AP1212 AP1216 AP1220

SERVICE MANUAL

smap12xx.pdf v.2.0 11/99
prev. rev. 06/93

Service Bulletin
 AP-1212, AP1216

ENLARGED VIEW OF ENCLOSED AREA

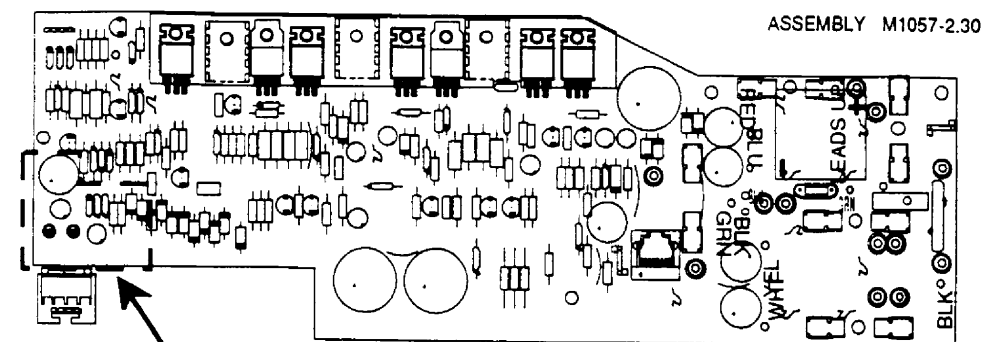
In locations where high levels of dust and smoke are present, the filterkit when cleaned regularly will prevent dust from entering the amplifier

Apply 1 piece of foam as shown. Inspect regularly as a clogged filter will cause the amplifier to overheat. Replace or

C11 SHOWN WITH CORRECTED POLARITY

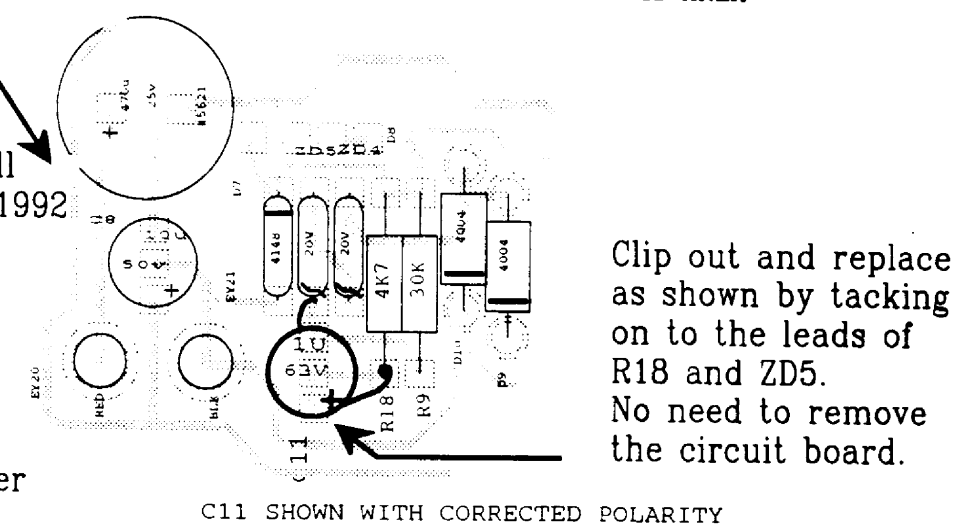
Due to a schematic error 'all units produced before Aug. 1992 (serial #208XXXX) have C11 backwards.

The eventual failure of this capacitor will reduce the maximum fan speed, possibly causing the amplifier to overheat.

Please replace with a new cap wired in correctly.

PLEASE DO THIS ON ALL UNITS THAT COME IN FOR SERVICE!
